**From:** [Shelly Lizotte](#)  
**To:** [Janine Murchison](#)  
**Cc:** [Penny Thompson](#); [Ellen Angel](#)  
**Subject:** RE: PD Site design  
**Date:** Thursday, February 27, 2025 10:14:45 AM  
**Attachments:** [image001.png](#)

**Subject:** PD Site design

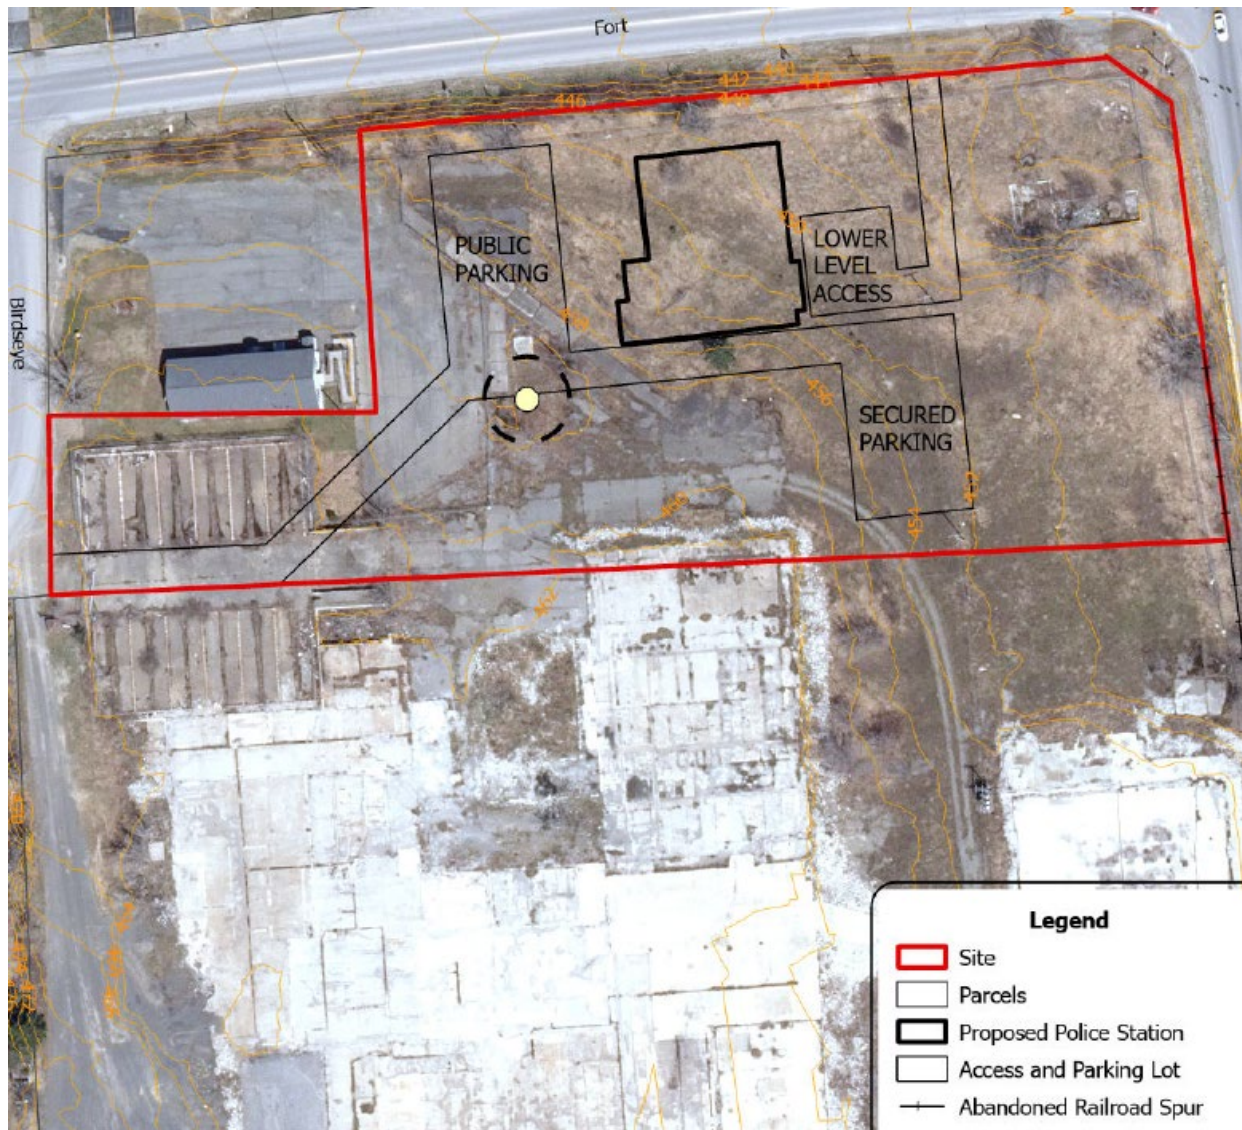
I was thinking just one underdrain (type B) on the south side, and to increase the cross slope to 3% on both the subgrade and the surface-similar to what you had sketched. If we were working with a clean/remediated site, I'd just do a deeper ditch on the south side and not even bother with the underdrain. The image below is from the Environmental Media Management Plan done by County Environmental – it used an older site sketch, but you can see the amount of concrete/pavement that remains.

Wouldn't it be great if all those old foundations were already gone – at least within the "boundary" of the PD lot. So, if the City would separate the cost of the entrance drive out of the PD project, we could cut back significantly more of the concrete to allow for the full depth ditch along that south side.
